THREE LANCASTER ESTATES SUBDIVISION

APPLICATION NUMBER 5 DATE March 17, 2016

DETAIL SITE PLAN

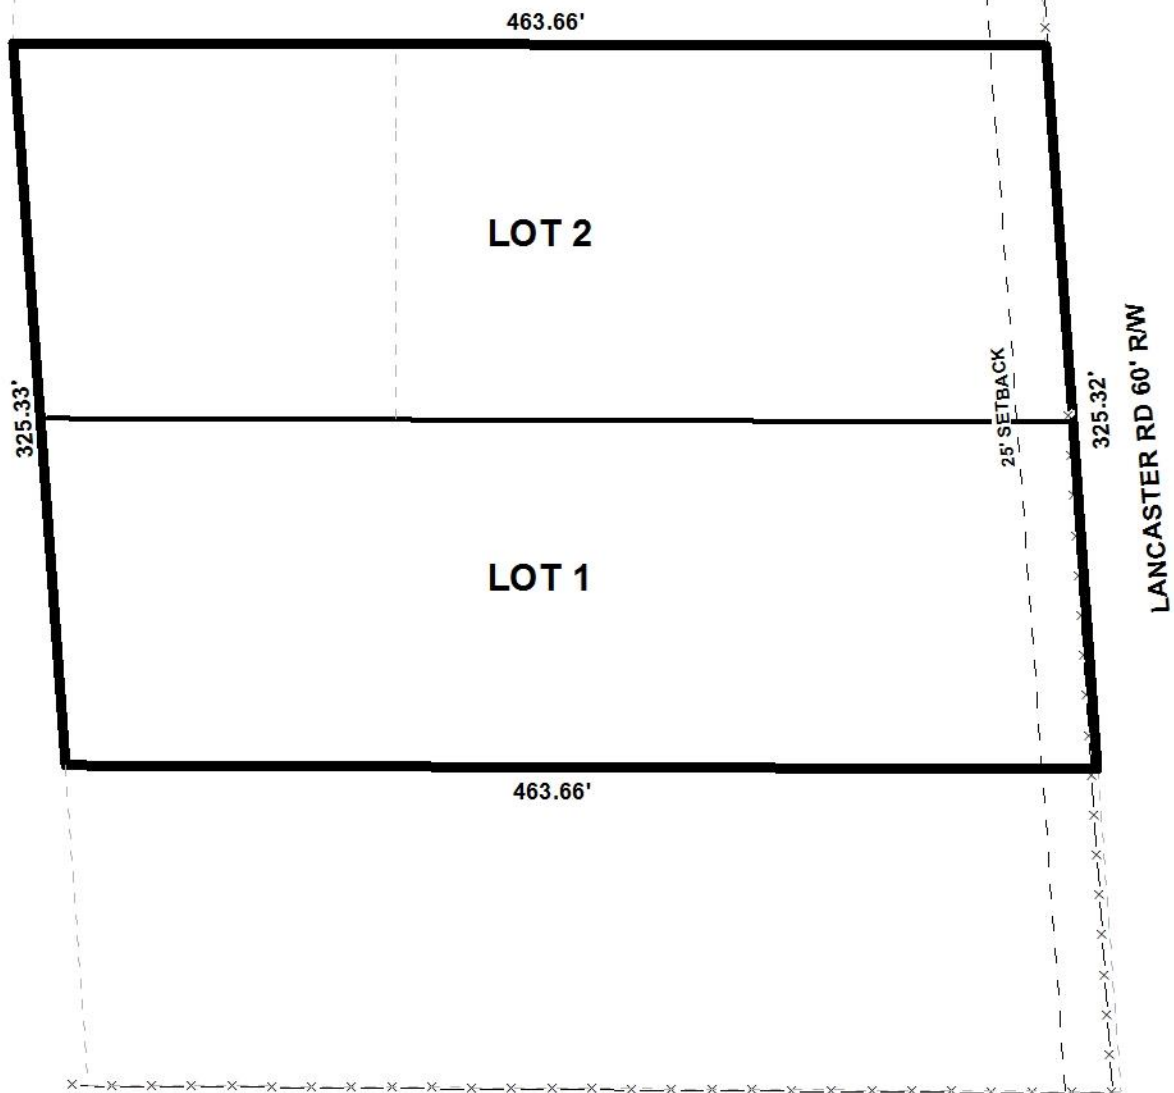
The proposed lots front Lancaster Road, a minor street without curb and gutter. As a minor street without curb and gutter, it requires a 60' right-of-way width in compliance with Section V.B.14. of the Subdivision Regulations. If approved, the Final Plat should retain the required 60' right-of-way width indicated along Lancaster Road.

The 25' minimum building setback line is depicted for each lot on the preliminary plat, and should be retained on the Final Plat, if approved.

The lot size is shown in both square feet and in acres on the preliminary plat, and if approved, should be retained on the Final Plat.

As a means of access management, a note should be placed on the Final Plat stating that the proposed lots should each be limited to one curb cut each to Lancaster Road, with any changes to the size, design and location of each curb-cut to be approved by Mobile County Engineering and conform to AASHTO standards.

This site is located in the County, therefore any lots which are developed commercially and adjoin residentially developed property must provide a buffer, in compliance with Section V.A.8. of the Subdivision Regulations. The aforementioned statement is indicated as a note on the preliminary plat and should be retained on the Final Plat, if approved.

- 1) Retention of the 60' right-of-way width along Lancaster Road;
- 2) Retention of the 25' minimum building setback line;
- 3) Retention of the lot size information in square feet and in acres on the Final Plat;

- 4) Retention of the note stating that both lots are limited to one curb each to Lancaster Road, with any changes in the size, design or location of the curb-cuts to be approved by Mobile County Engineering and conform to AASHTO standards on the Final Plat;

- 5) Placement of a note on the Final Plat stating: *(This site is located in the County, and therefore any lots which are developed commercially and adjoin residentially developed property must provide a buffer, in compliance with Section V.A.8. of the Subdivision Regulations.);*
